IN THE DRAWINGS

APPLICATION NO. 10/078,056
REPLY TO OFFICE ACTION OF AUGUST 24, 2004
ANNOTATED SHEET SHOWING CHANGES

FIG. 3

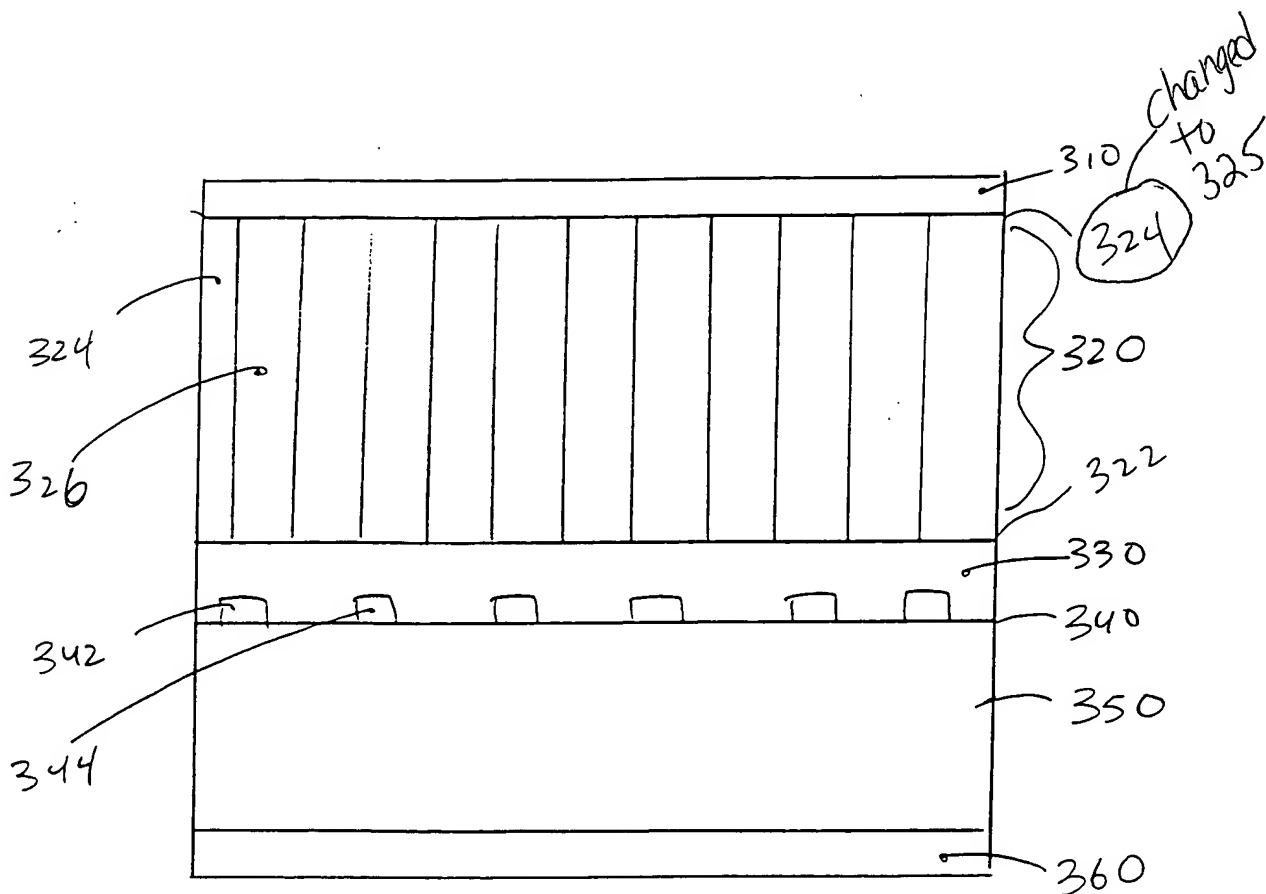
The attached drawing sheet includes a change to Figure 3. The sheet replaces the original sheet including Figure 3. The figure has been amended to correct a reference numeral. It is respectfully submitted that the proposed amendment to the drawing does not add new matter.
